SERVICE BULLETIN

from: TRIO-KENWOOD COMMUNICATIONS, INC.

No. 2

SUBJECT: TS-520 Novice Operation (75 watts)

Figure 1 (Bottom side)

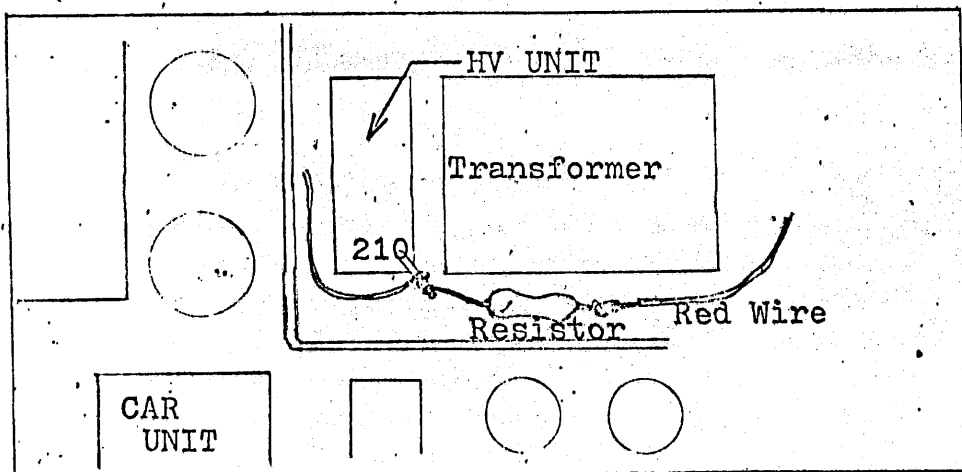
1. Cut wire (see figure 1) red color.
2. Insert 33Kohm resistor in series between red wire and pin 210.
3. Readjust bias current to 60ma.
